Re: Comments on the Draft Supplement Environmental Impact Report  
(SCH. No. 2010111056) for the Proposed Le Conte Energy Storage  
System Project (CUP No. 180018)

On behalf of the **Citizens for Responsible Industry**, we submit these comments on the Draft Supplemental Environmental Impact Report ("DSEIR") for the Le Conte Battery Energy Storage Project, a proposed 125 megawatt ("MW") battery energy storage facility, located on 3-5 acres of land in southeastern Imperial County ("County") at 319 Brockman Road, Calexico, California.

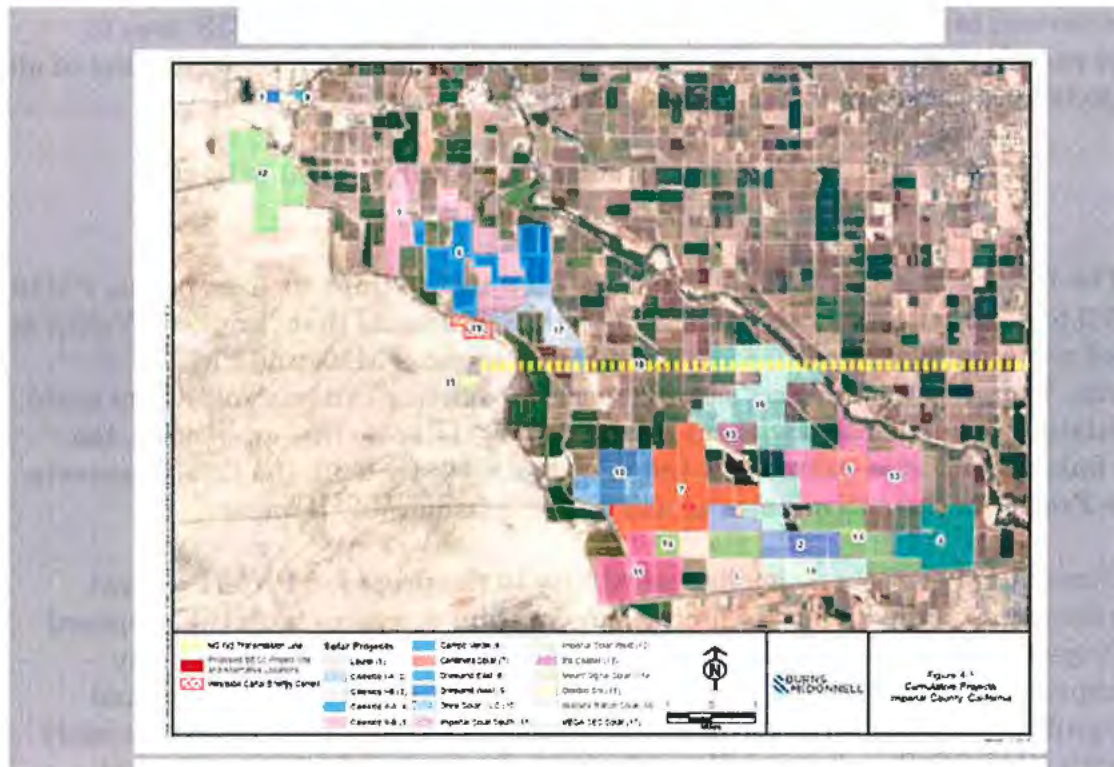
But Table 4-1 omits multiple similar projects located within the SSAB without explanation, including multiple solar plants located in and around the city of Calipatria.<sup>150</sup> Thus, while the DSEIR claims to use the SSAB as the geographical

Moreover, the DSEIR does not explain why this more limited geographic scope was chosen for examining cumulative impacts and the chosen area seems to be entirely arbitrary, violating CEQA's requirement to "provide a reasonable explanation for the geographic limitation used."<sup>152</sup> Even more bewildering, the cumulative impacts analysis excludes projects located within this smaller, arbitrarily-chosen geographic scope. For example, the Heber Solar Project, located

approximately 6 miles northeast of the project is excluded without explanation.<sup>153</sup> A comprehensive list of the past, present, and probable future projects is “necessary to an adequate discussion of significant cumulative impacts.”<sup>154</sup> Thus, the DSEIR must be revised to correctly identify which geographic scope the DSEIR uses to examine cumulative impacts on air quality and to include a comprehensive list of all the projects located within that geographic region.

The DSEIR must be revised to either conduct an adequate cumulative impacts analysis, or revised with evidence showing that the Project will not overlap its construction phase with other projects. By failing to include that information, the DSEIR relies on empty conclusory statements and assumptions to evade a proper cumulative impacts analysis, thus violating CEQA.
